**REVISED EXPRESS TERMS  
FOR  
PROPOSED BUILDING STANDARDS  
OF THE  
DEPARTMENT OF HOUSING AND COMMUNITY DEVELOPMENT  
REGARDING THE ADOPTION OF THE  
2013 EDITION OF THE CALIFORNIA BUILDING CODE  
CALIFORNIA CODE OF REGULATIONS, TITLE 24, PART 2, CHAPTER 11A “HOUSING ACCESSIBILITY”  
(HCD 08/12)**

**8. HCD proposes to amend Division VII – FIGURES as follows:**

**FIGURE 11A-3B  
CURB DETAIL**

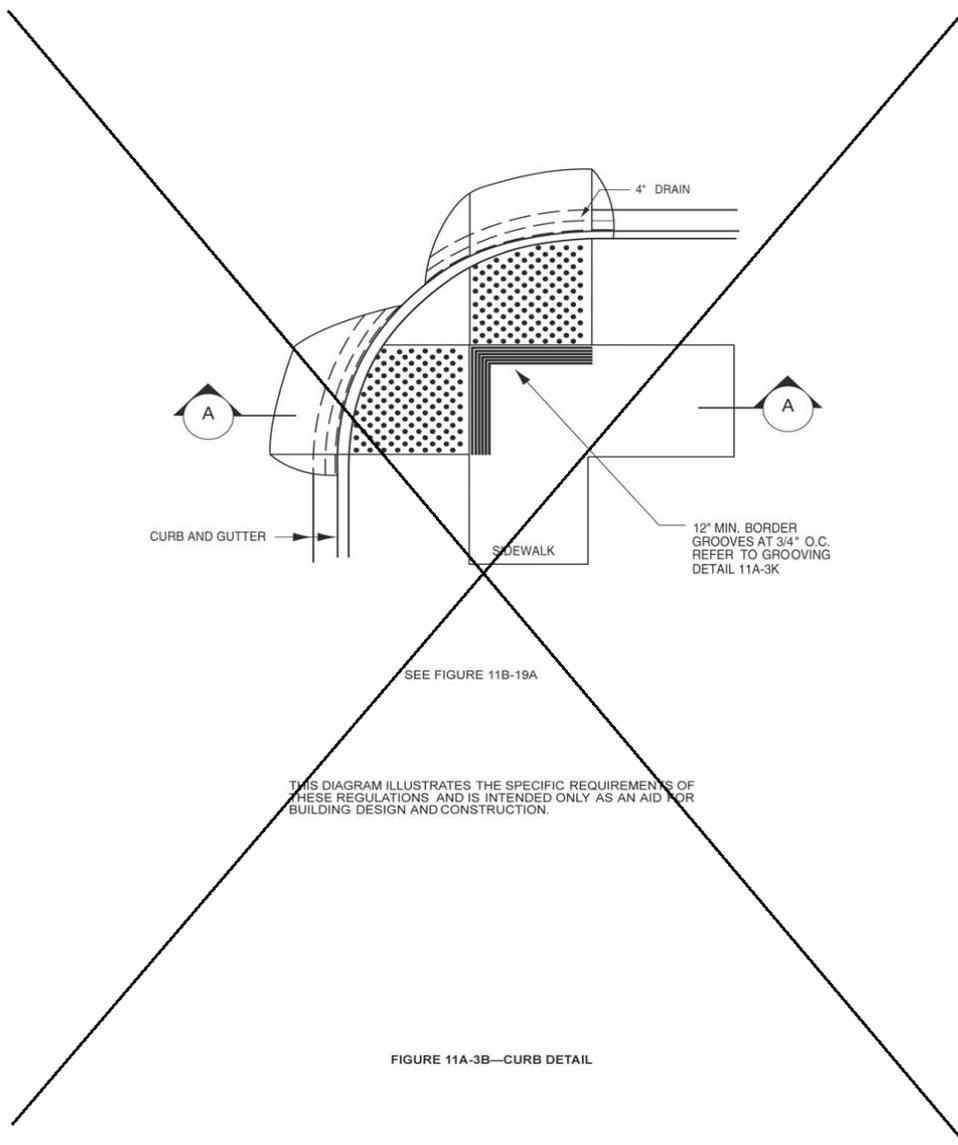
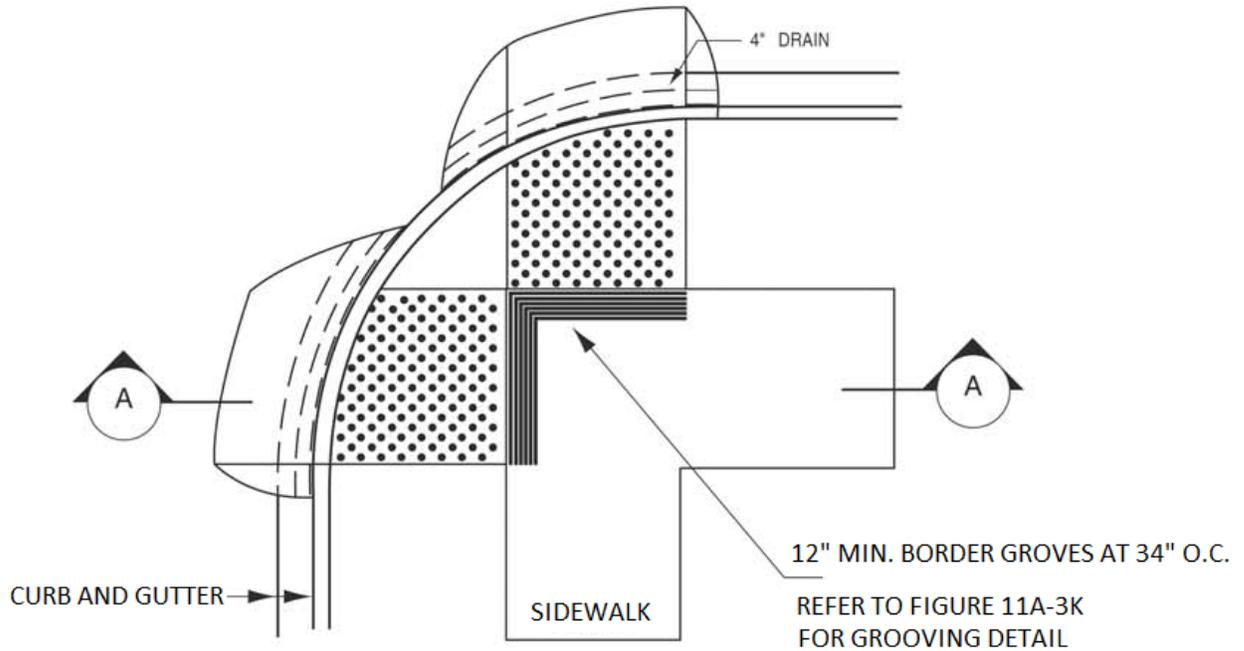
HCD initially intended to show in the Express Terms figures proposed to be amended as “X’d out”, followed by the newly proposed figure on the next page instead of the standard format with strike-out and underline. The decision was made to provide more clarity to the stakeholders involved in the rulemaking process. All figures, but two, were proposed in the new format. HCD proposes to modify Figure 11A-3-B, correcting the oversight. There is no intended change in regulatory effect.

FIGURE 11A-9A  
TOILET FACILITIES

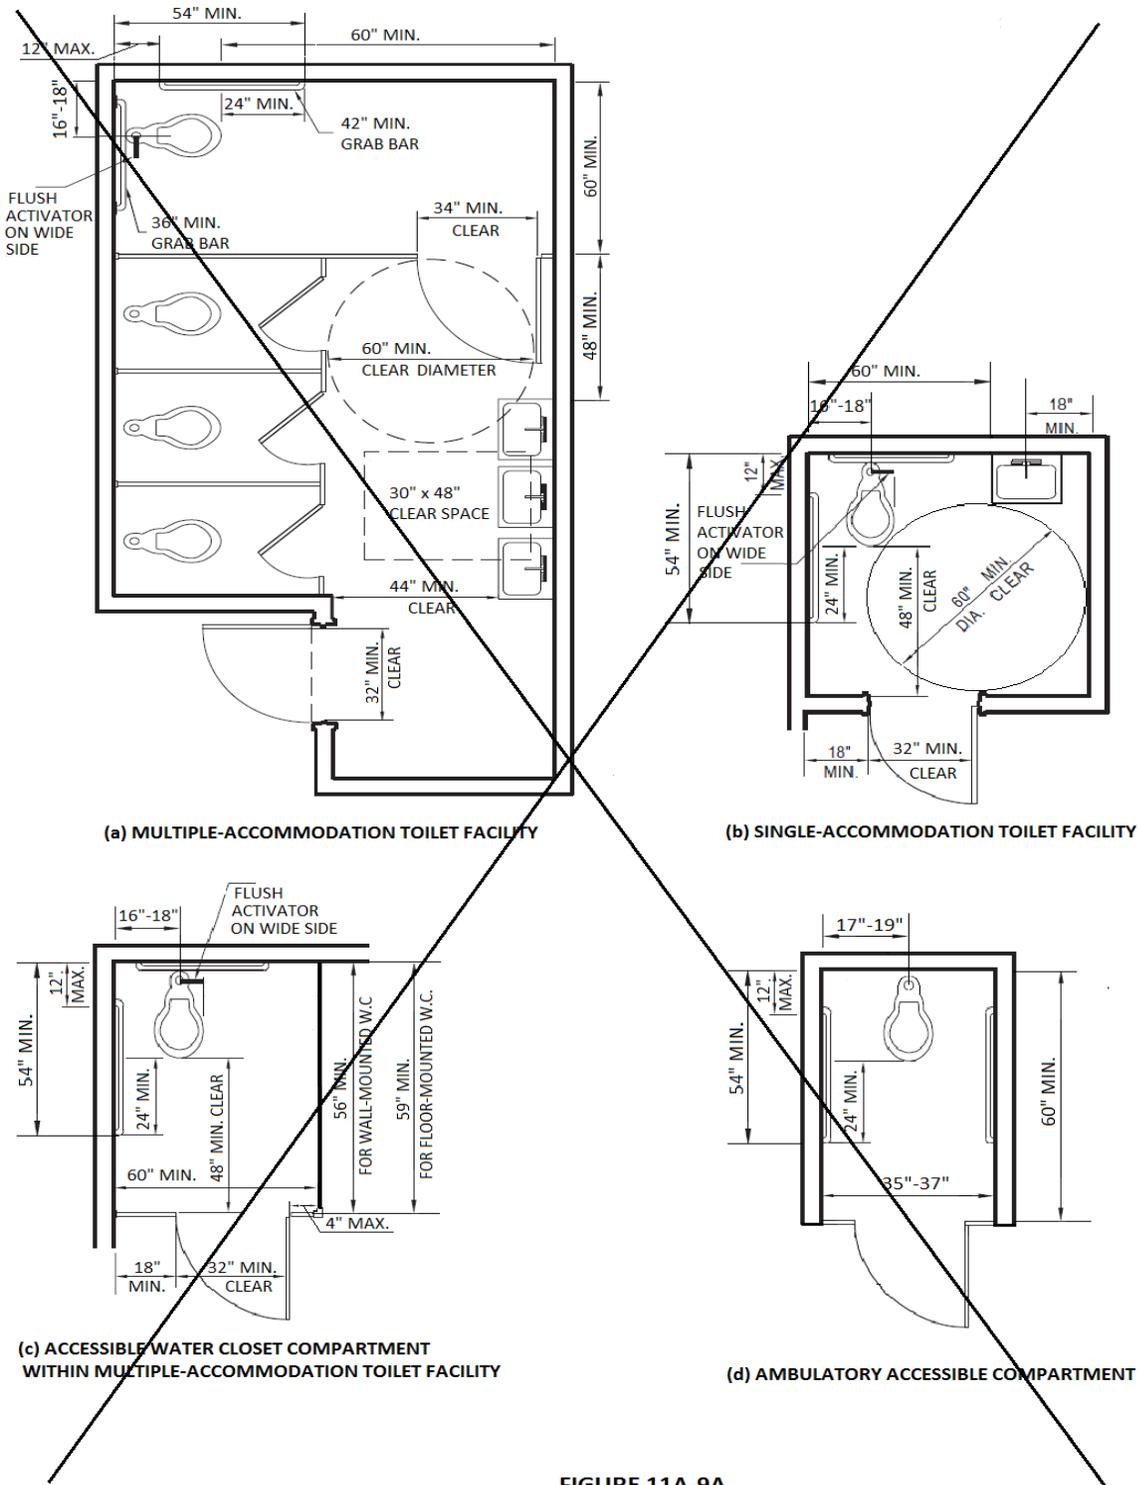
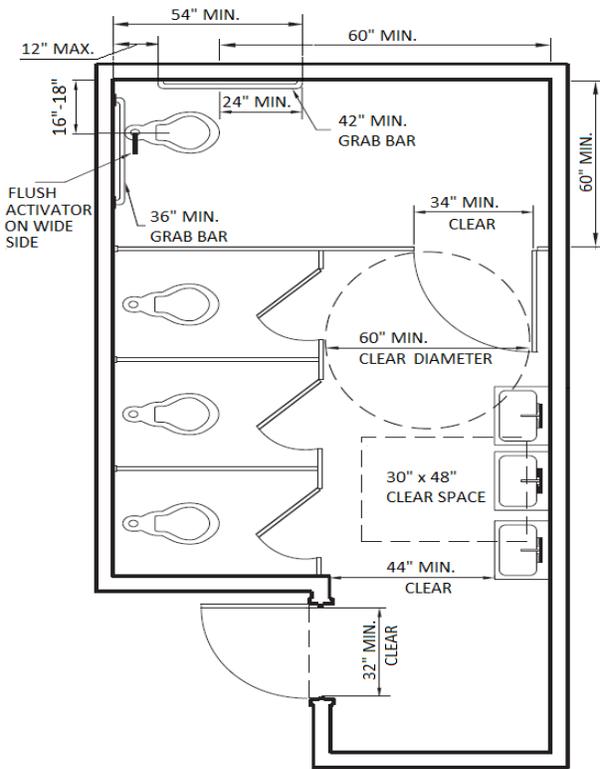
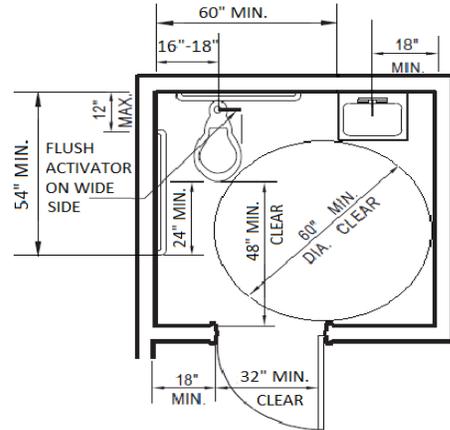
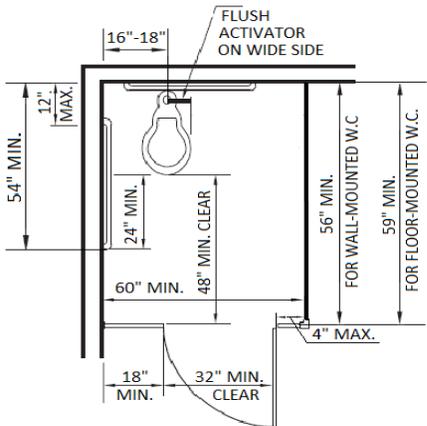
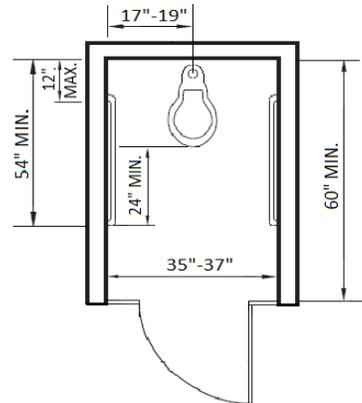
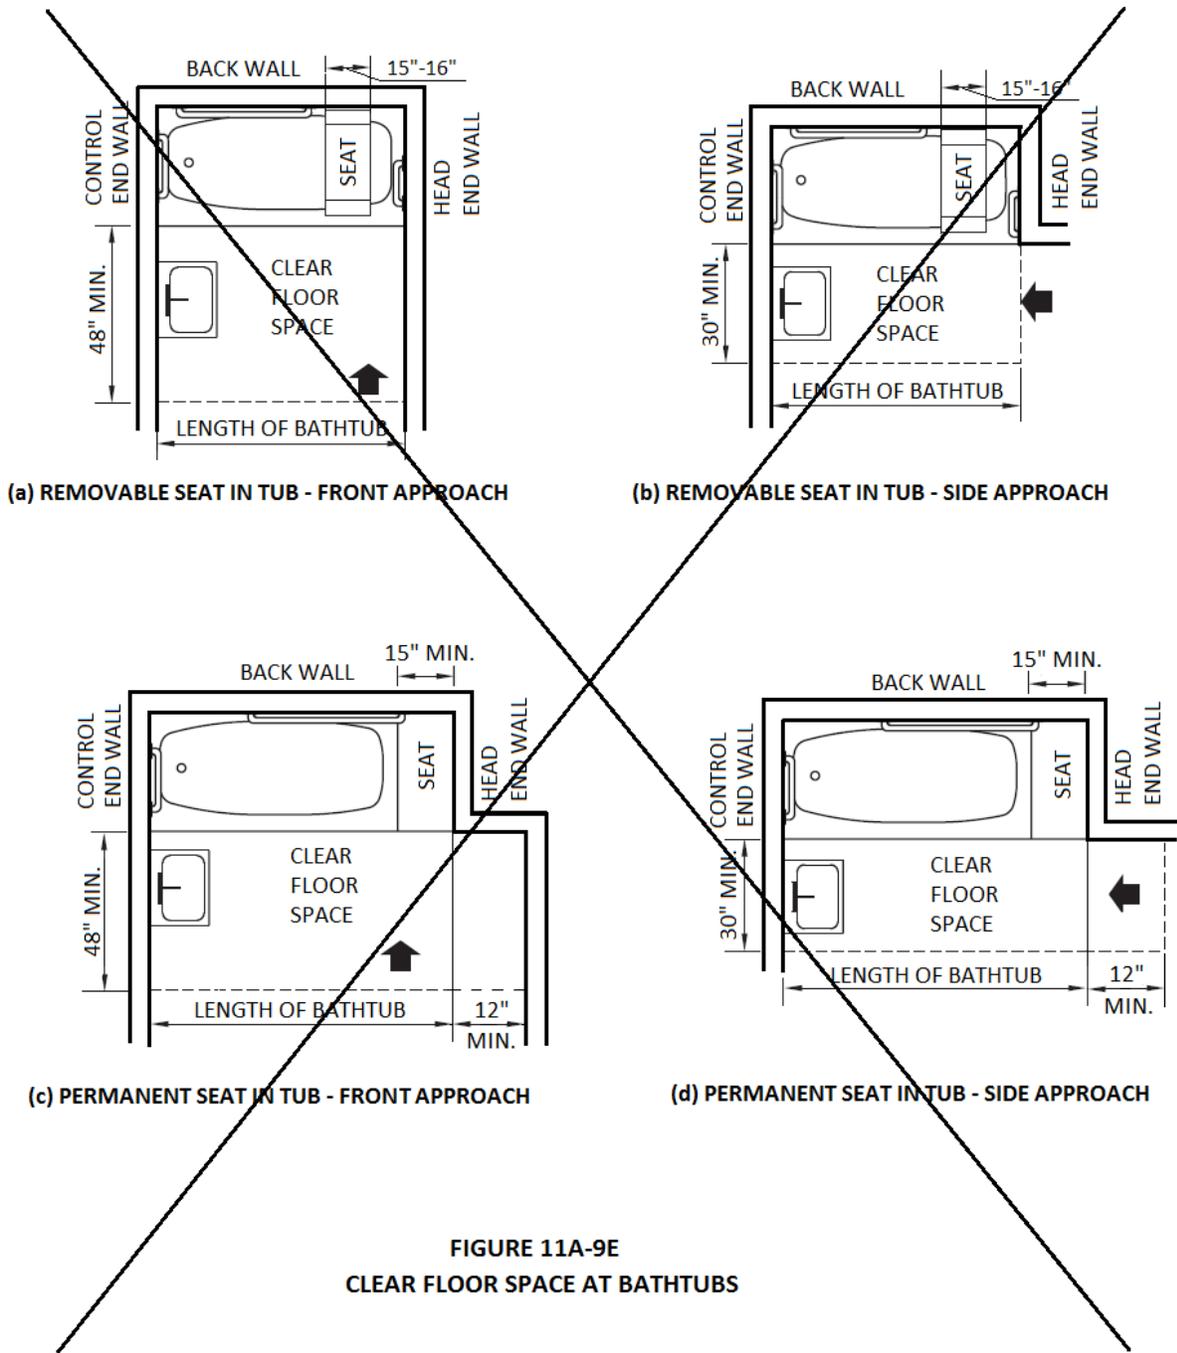
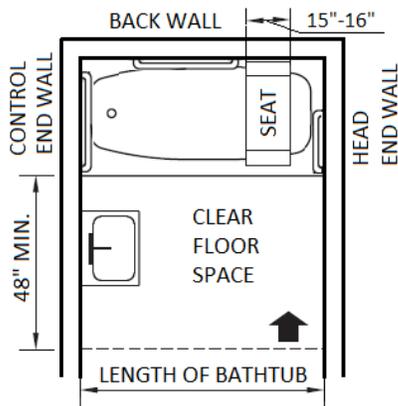
During the 45-day public comment period, HCD received a comment suggesting revisions to Figure 11A-9A. The commenter expressed a concern that the figure incorrectly shows the minimum landing length of 48 inches

minimum in front of the compartment door. The commenter also expressed an opinion that the dimension is technically correct, but only if the door swings in.

HCD initially proposed to modify this diagram, adding the minimum dimension of 48 inches required by Section 1127A.2.1, for more clarity. However, staff agreed with the commenter that this dimension may conflict with Section 11267A.3 in some cases, which provides the general requirements for maneuvering clearances at doors. The 48 inches minimum in front of a water closet compartment is a correct dimension, but only if the door swings in. If the door swings out as illustrated on Figure 11A-9A (a), then Section 1126A.3 requires 60 inches minimum. HCD proposes to modify Figure 11A-9A (a) and remove the dimension of 48 inches.

FIGURE 11A-9E  
CLEAR FLOOR SPACE AT BATHTUBS

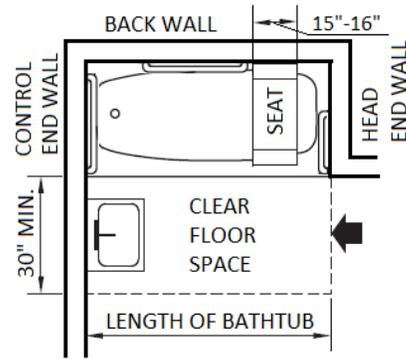
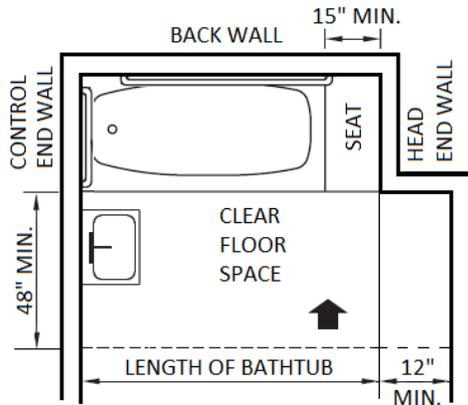
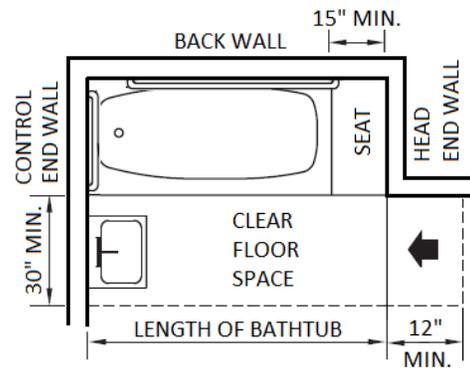
During the 45-day public comment period, HCD received a comment suggesting revisions to Figure 11A-9E in regard to the grab bars dimensions. The commenter expressed an opinion that the figures should be drawn consistent graphically with the specified dimensions in the code. All figures in Chapter 11A, including Figure 11A-9E, are not drawn to scale, and are provided for illustration purposes only. As described in the title,

Figure 11A-9E is intended to illustrate the clear floor space at bathtubs, not the grab bars length. The grab bar dimensions at bathtubs are shown on Figure 11A-9F. However, to provide more clarity, HCD proposes to modify Figure 11A-9E. The length of grab bars is corrected to illustrate an approximate scale. The actual size of required grab bars required by Section 1127A.5.2.3 is found in Figure 11A-9F. HCD also proposes to add a note clarifying that the size of grab bars is shown on Figure 11A-9F. There is no intended change in regulatory effect.

**FIGURE 11A-11A  
DRINKING FOUNTAINS**

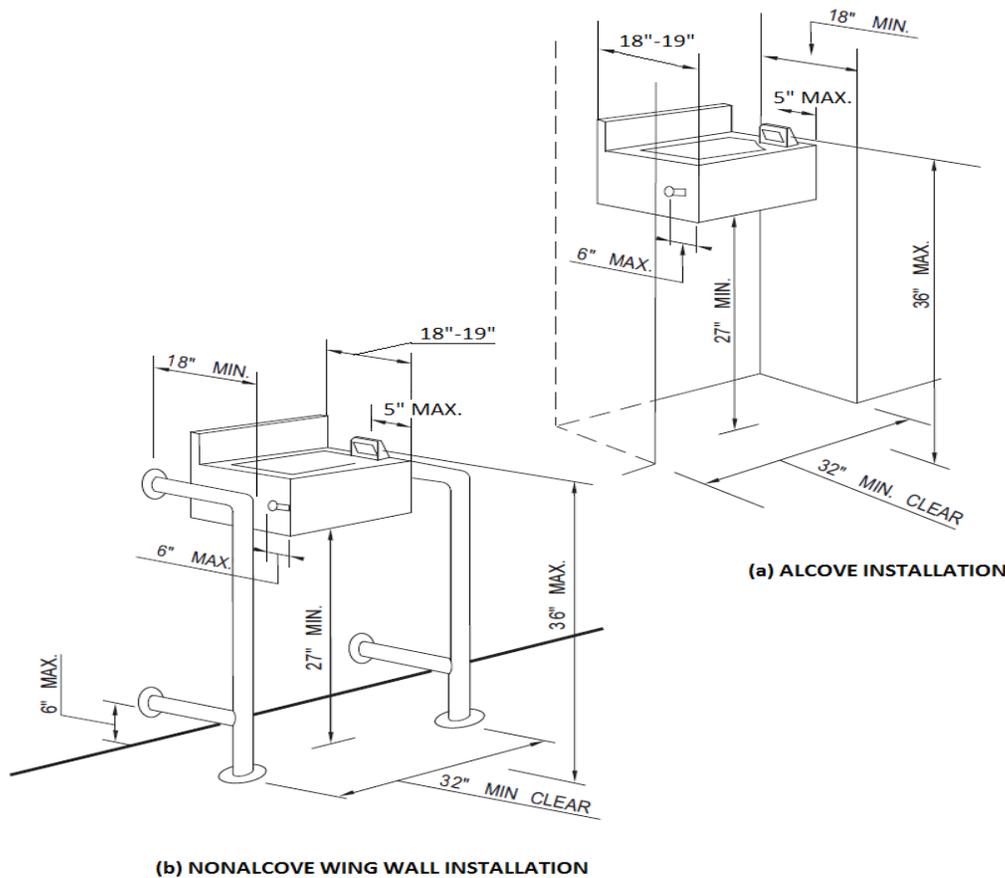
HCD initially intended to show in the Express Terms figures proposed to be amended as “X’d out”, followed by the newly proposed figure on the next page, instead the standard format with strike-out and underline. The decision was made to provide more clarity to the stakeholders, involved in the rulemaking process. All figures, but two, were proposed in the new format. HCD proposes to modify Figure 11A-11A, correcting the oversight. There is no intended change in regulatory effect.
